PIC16(L)F1938/1939 Silicon Errata and Data Sheet Clarification

The PIC16(L)F1938/1939 family devices that you have received conform functionally to the current Device Data Sheet (DS40001574C), except for the anomalies described in this document.

FIGURE 1: INSTRUCTION CYCLE DELAY CALCULATION EXAMPLE

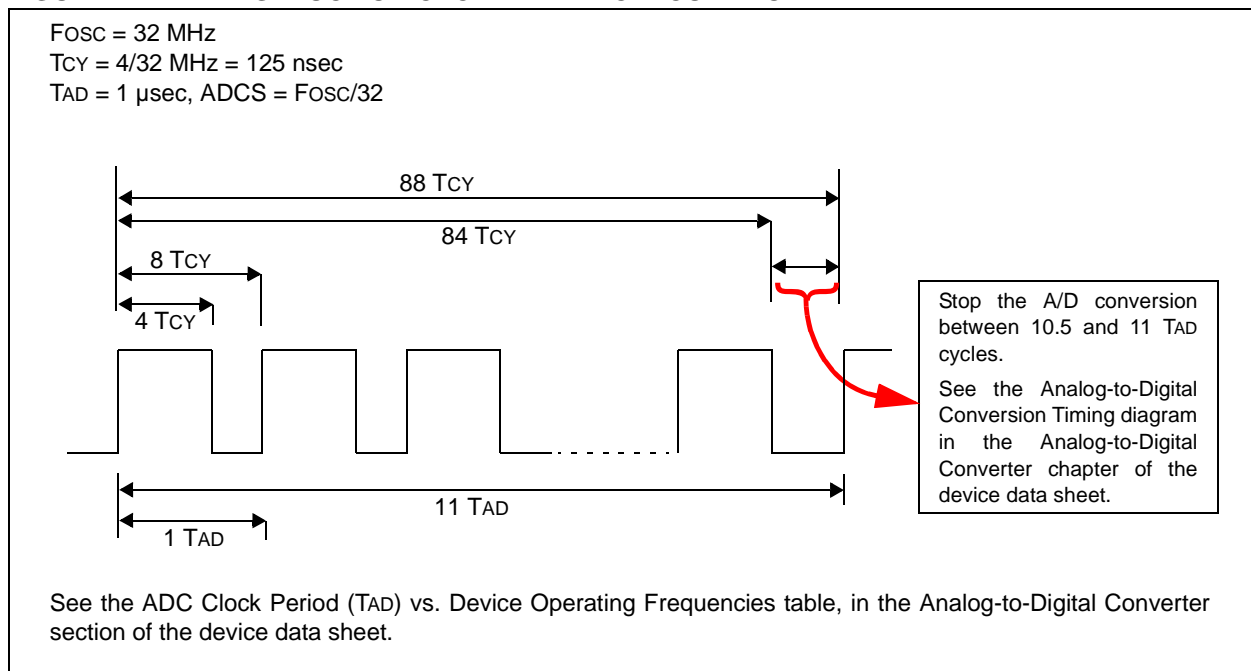
An ADC conversion may not complete under these conditions:

1. When FOSC is greater than 8 MHz and it is the clock source used for the ADC converter.
2. The ADC is operating from its dedicated internal FRC oscillator and the device is not in Sleep mode (any FOSC frequency).

When this occurs, the ADC Interrupt Flag (ADIF) does not get set, the GO/DONE bit does not get cleared, and the conversion result does not get loaded into the ADRESH and ADRESL result registers.

Method 3: This method is provided if the application cannot use Sleep mode and requires continuous operation at frequencies above 8 MHz. This method requires early termination of an ADC conversion. Provide a fixed time delay in software to stop the A-to-D conversion manually, after all 10 bits are converted, but before the conversion would complete automatically. The conversion is stopped by clearing the GO/DONE bit in software. The GO/DONE bit must be cleared during the last 1/2 TAD cycle, before the conversion would have completed automatically. Refer to [Figure 1](#) for details.

In Figure 1, 88 instruction cycles (Tcy) will be required to complete the full conversion. Each TAD cycle consists of 8 Tcy periods. A fixed delay is provided to stop the A/D conversion after 86 instruction cycles and terminate the conversion at the correct time as shown in the figure above.

Note: The exact delay time will depend on the TAD divisor (ADCS) selection. The Tcy counts shown in the timing diagram above apply to this example only. Refer to Table 3 for the required delay counts for other configurations.
